Attachment 1 - PLN18/0990 - 419 Fitzroy Street, Fitzroy - Site Plan

Attachment 2 - PLN18/0990 - 419 Fitzroy Street Fitzroy - S52 Advertising Plans

ROSE STREET HOTEL 419 FITZROY STREET

Thank you for the opportunity to review the application package for the proposed 7 storey hotel development at **419 Fitzroy Street, Fitzroy**. We have reviewed the plans prepared by Woods Bagot Architects, dated 6 February 2019 and inspected the site and the surrounds.

Vehicle Crossing – Cross Section

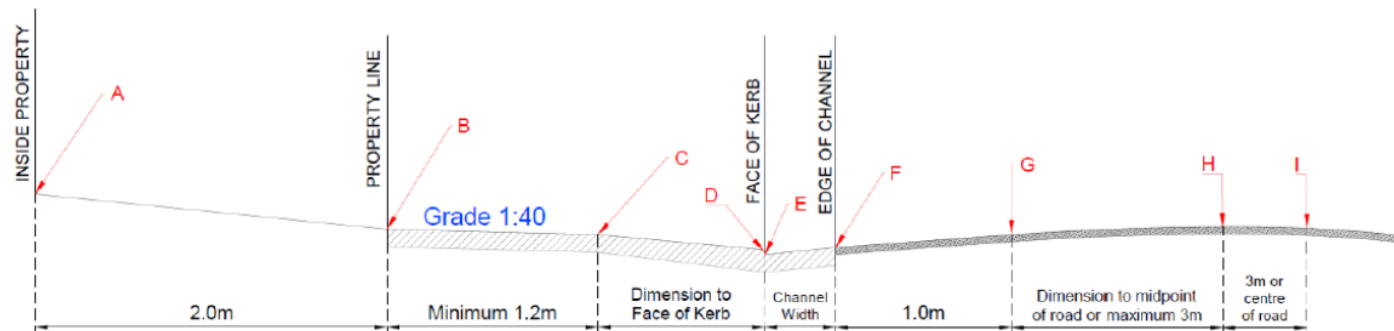
The designer is to submit a 1:20 scale cross section for each proposed vehicle crossing showing the following items:

- A. Finished floor level 2.0 metres inside property
- B. Property line surface level
- C. Surface level at change in grade (if applicable)
- D. Bullnose (max height 60mm) – must be clearly labelled
- E. Surface level at the bottom of the kerb
- F. Surface level at the edge of channel
- G. Road level 1.0 meter from the edge of channel
- H., I. Road levels

- o Please note the cross section must be fully dimensioned. As shown in the sketch below.
- o Please show both the existing and proposed surface.
- o The maximum allowable cross-fall between points B and C is 1:40 (2.5%).
- o A bullnose (max 60mm) is permitted at point D, however not compulsory.
- o The levels shown must be exact reduced levels, to three decimal points. Interpolation of levels is not acceptable.
- o The designer must demonstrate that an 85th or 99th percentile vehicle profile can traverse the design cross section as per the Australian/New Zealand Standard ground clearance template (AS/NZS 2890.1:2004).
- o Significant level changes to the existing footpath level B to C will require additional level design either side of the proposed crossing.
- o Please include any additional levels or changes in grade that are not shown in the diagram.

Diagram demonstrating marginal variation to the established building height ‘datum’ along Rose Street.

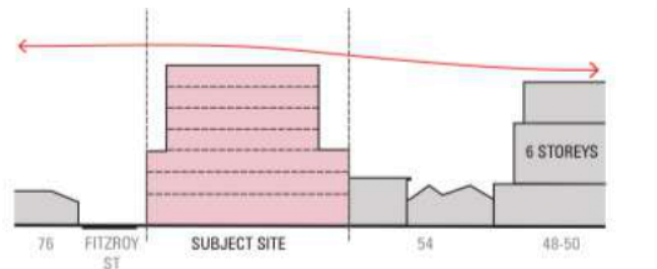
- In the absence of specific height controls for this site, a number of urban design tests are required to determine appropriate site- specific response for a fully supportable outcome. Firstly, the question of a 7-storey built form has to be considered in relation to its current and emerging morphological role in providing urban hierarchy and legibility to its host precinct. The subject site benefits from a corner location with an opportunity to hold the junction with a more prominent form. Where recent mid-rise development along Rose Street are in the order of 6 storeys, the proposed scale does not represent a drastic departure from the common order whilst still reinforcing the junction, contributing to the legibility of this precinct as demonstrated in diagram below.

Diagram demonstrating the reasonable 'building line' of the proposal along Fitzroy Street (east)

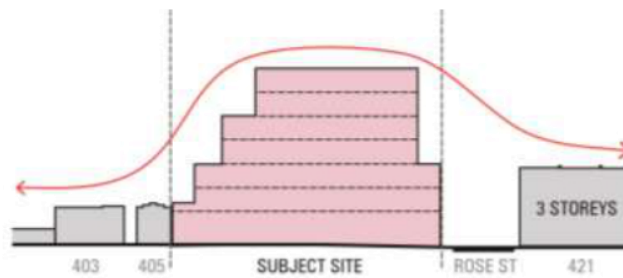
- Along Fitzroy Street, the potential to accommodate taller forms to the fine grain adjacencies is expected where renewal can be anticipated on ex-industrial sites. While the built form ultimately rises to a height of 7 storeys, it is notable through the inspections of elevations that the upper most reaches are setback 18.5m from the rear boundary. The proposal has devised a response to its role as a corner with a sense of transition to the existing and future development to the south, as shown below. We believe that the proposal is well justified in terms of its current and emerging urban morphological contexts.

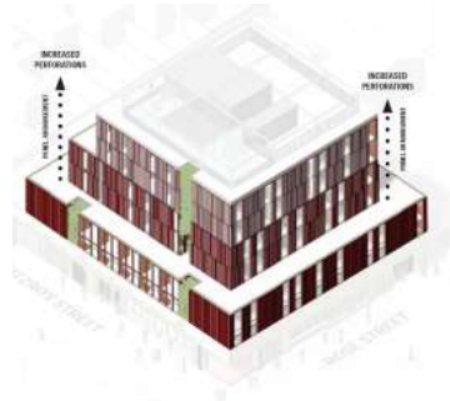
- In its current arrangement, Fitzroy Street provides a continuous, north – south aligned pedestrian link between Victoria Parade and Alexandra Parade. Where Fitzroy Street intersects with Victoria and Johnston Streets, these junctions are defined by robust, contemporary forms (at 69 Victoria Street and 89 Johnston Street). This distinction assists in demarcating the approach to Johnston Street, one of key commercial streets in the City of Yarra. We feel a 3m setback along Fitzroy St is acceptable that it anchors the Rose Street northern/ southern approaches, contributing to locating it as a special ‘node’, or destination. The 3m setback appears not to detrimentally affect amenity within the public realm with shadow impact limited to after 2pm on 22 September.

The proposed massing strategy comprising street wall (3 storey) response along Rose and Fitzroy Streets is appropriate

- Through a combination of low-rise street walls and setback upper levels, this part of Rose and Fitzroy Streets have managed to retain an intimate pedestrian streetscape profile and view to the sky. The proposed 3 storey street wall (10.9m) demonstrates a proportionate response to the narrow Rose/ Fitzroy streets profile (approximately 10m wide). Along these street frontages, upper levels are setback 3m behind the street walls, ensuring pedestrian experience at the street level is not overwhelmed by the rising form.

- The preferred upper level setback should emphasize the distinction between ‘base’ podium and ‘top’ upper levels – consistent with the massing objectives found in the Urban Context Report prepared by SJB (page 24). We recommend an upper level setback of up to 4m along Rose Street to match upper level setbacks established by recent developments at 48-50 Rose Street and 45 Rose Street. Whilst a 3m setback offer some level of distinction between the base and top, a 4m setback to Rose Street has an added benefit of continuing the setback ‘datum’ established by other contemporary development along this streetscape.

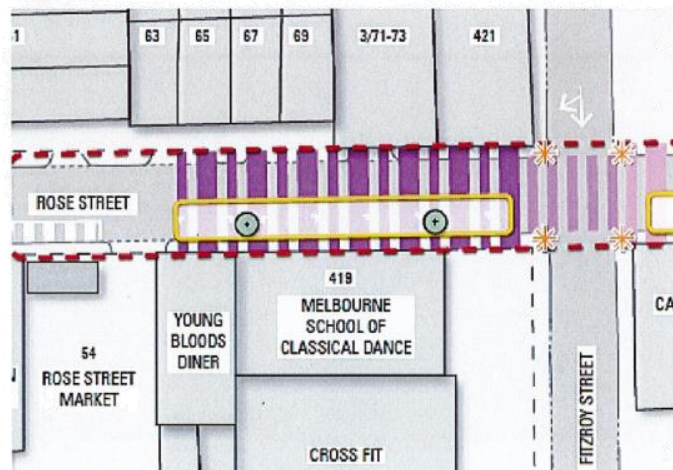
- Is the proposed ground floor interface along Rose Street supported when taking into account the proposed Rose Street Shared Zone? If not, please clarify reasons for this position. Refer to the red circled area in the first screenshot below.

The ground floor interface along Rose Street is supported. The proposed activities are within their boundary and would unlikely impact the shared zone.
